Chesterfield Cycle Campaign Response to public consultation on Staveley Regeneration Route

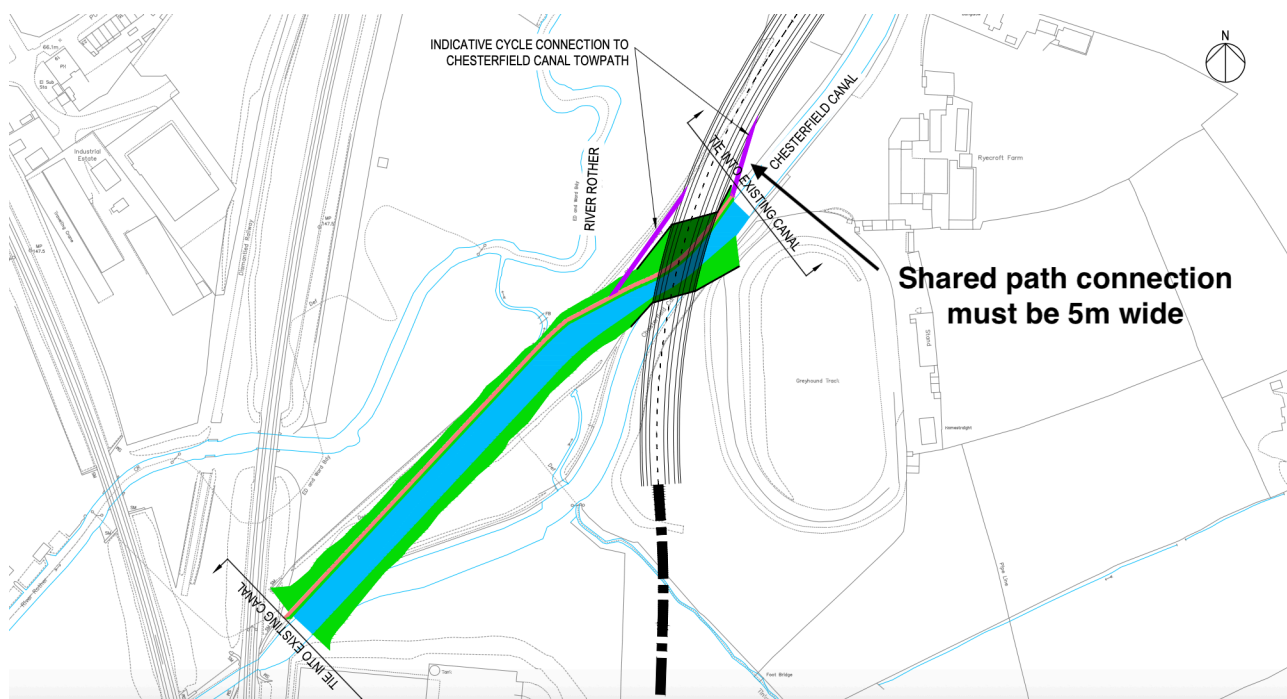
On the eastern side of the route from the roundabout there is a shared path - following an online meeting with AECOM we understand the existing shared path will remain but change to a segregated route when the new build road starts. This is essential if the residents of Heritage Green are to be able to access the route.

We urge DCC to consider providing a cycle route from the Sainsbury's roundabout to connect with existing cycle infrastructure to the south.

At the site of the first new canal crossing there are indicative 'ramps' from both sides of the proposed road linking onto the canal towpath. Presumably the one on the eastern side will be a shared path. As such it will need to maintain a 5m width and the gradient will need consideration in line with LTN 1/20. There is no need for the 'cycle connection' shown on the western side because there is no cycle path on that side.

Station Road

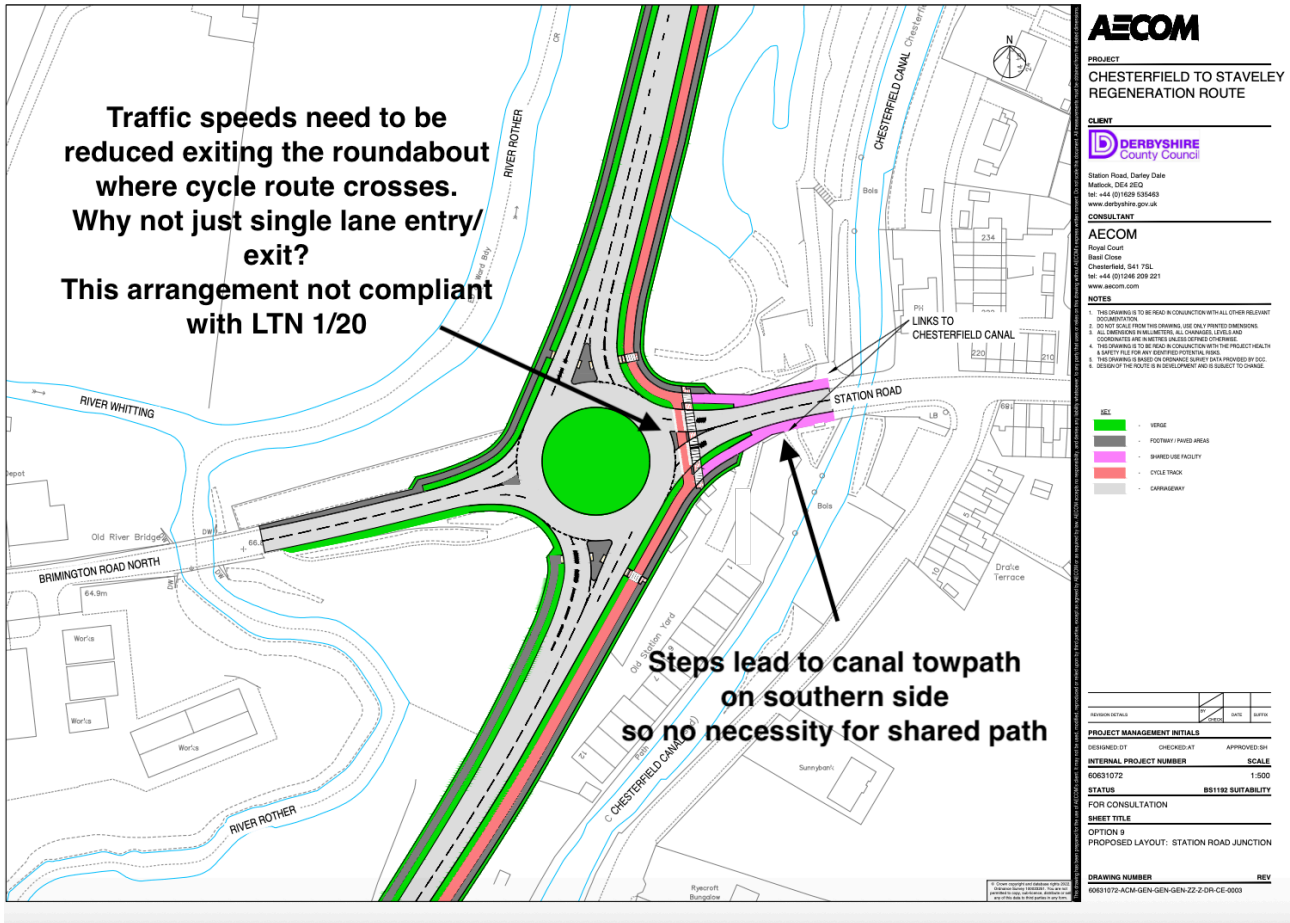
The roundabout on Station Road creates a dangerous crossing for cyclists. If the road from Brimington was just a single lane entry and exit cyclists and pedestrians will find it easier to cross. We are very concerned that the arrangement shown will allow greater vehicle speeds and no space for vehicles to stop to allow pedestrians and cyclists to cross without blocking the roundabout.

Bluebank Loop/Newbridge Lane

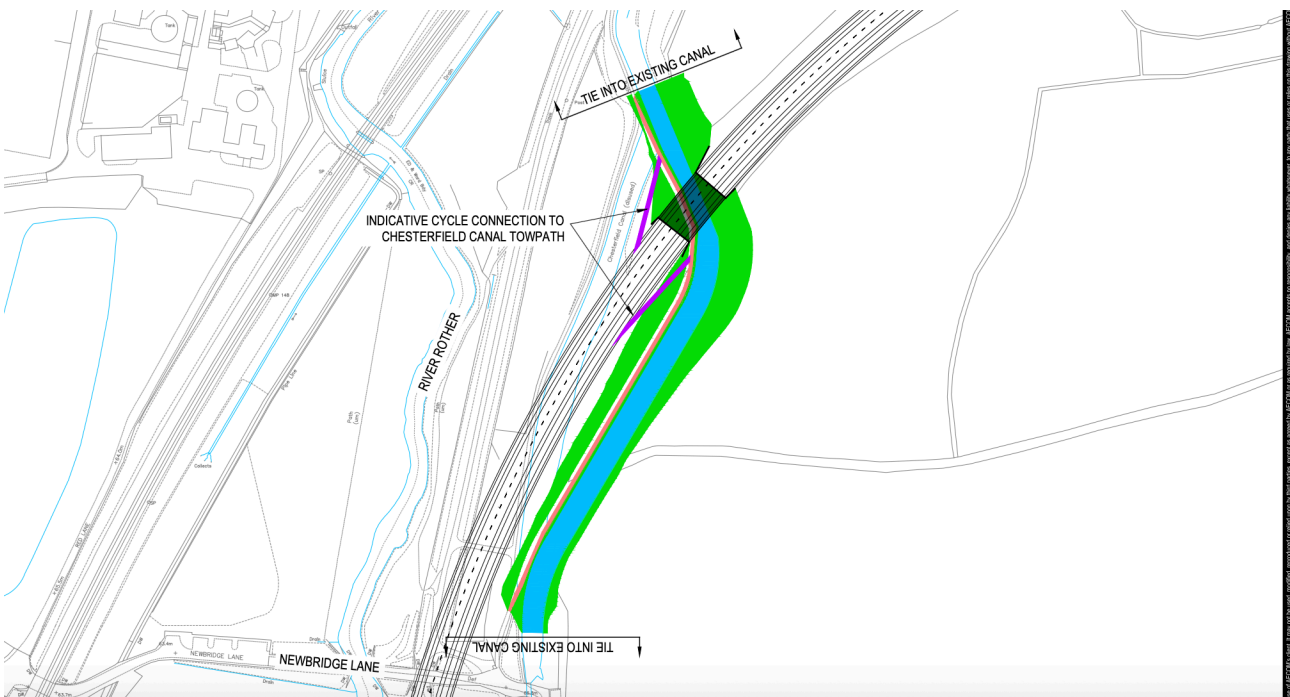
Newbridge Lane (to the north/west) forms a good pedestrian and cycle link towards Whittington Hill. From our meeting we understand this connection will be maintained 'at grade'.

The proposed road appears to be built along the line of the Bluebank Loop. Do we assume that cycle route is lost? At this location cyclists are directed away from the towpath onto the Loop. If that is no longer possible the towpath will need upgrading to become shared which we have been told will be completed as part of the canal rerouting.

Where the second new crossing of the canal is shown the connecting paths between the road and canal towpath have the same comments as the first crossing with regard to width and gradient.

Works Road Hollingwood

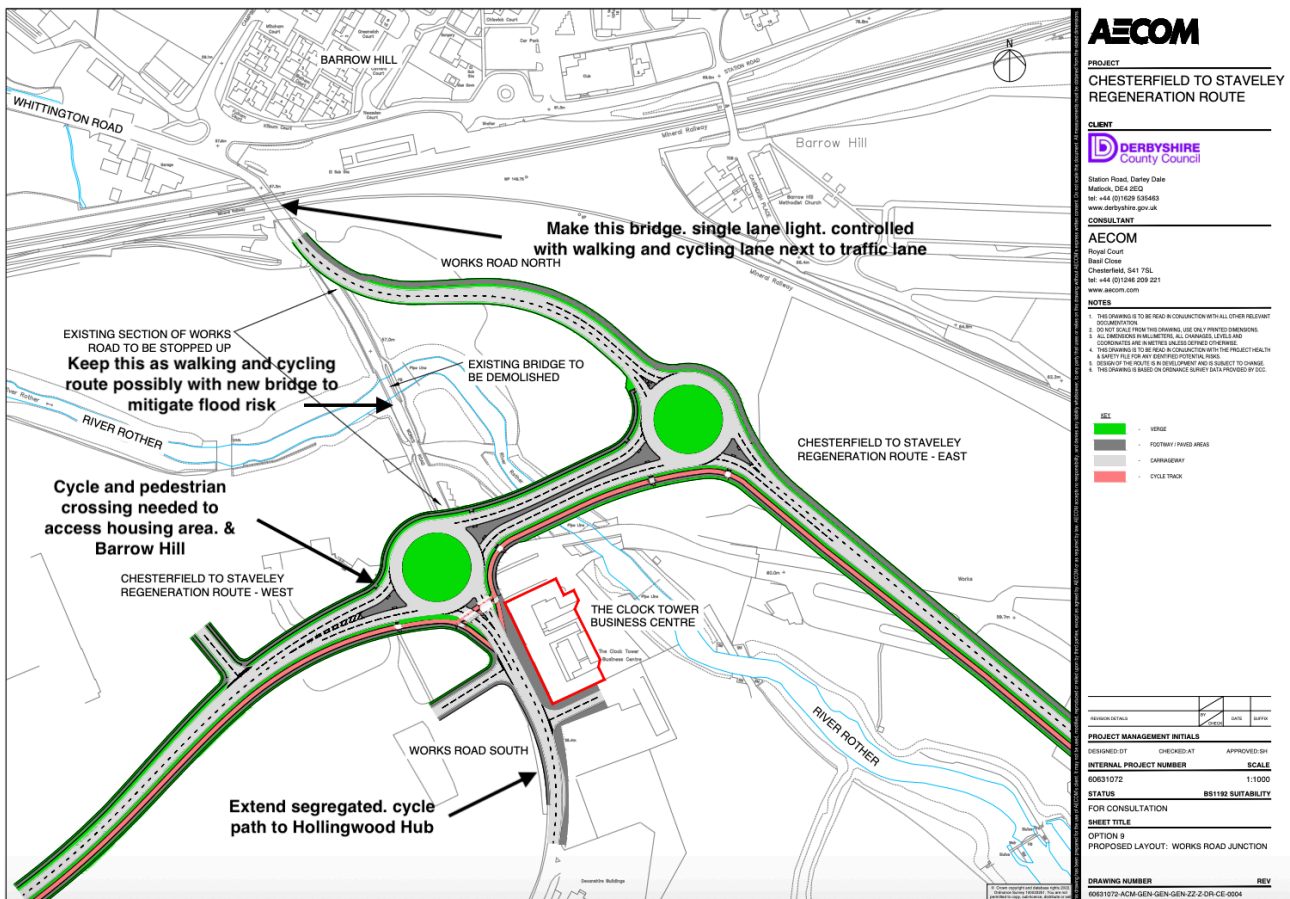
The same comments as the roundabout on Station Road apply to the first roundabout on Works Road regarding cyclists crossing 4 lanes of traffic. The exit and entry onto the roundabout should only be one lane wide and follow the Dutch example of slowing traffic down by road design, not facilitating higher speeds.

Barrow Hill is pretty much cut off from the cycle route alongside the canal and this road. If at all possible we suggest the 'old' part of Works Road be retained as a walking and cycling route which would at least provide the beginnings of a connection to Barrow Hill. We understand the bridge to be demolished is because of flood risk. Within this scheme costing £130M it doesn't seem unreasonable to provide a new bridge to facilitate traffic free walking and cycling. With the potential for restarting passenger services from Barrow Hill on the existing railway line there should be thought and provision for walking and cycling to the site of the new station.

Given the housing developments that are planned adjacent to the new road it is surprising that no cycle links are planned to get to the other side of the road especially near Works Road. The cycle route should be extended alongside Works Road South to meet the canal at the Hollingwood Hub.

No further comments on the proposed cycle facilities other than remove the stub off the existing roundabout adjacent to Staveley Basin which presumably due to boggy ground and levels will never be used, the cycle path then no longer needs the dog leg round it.
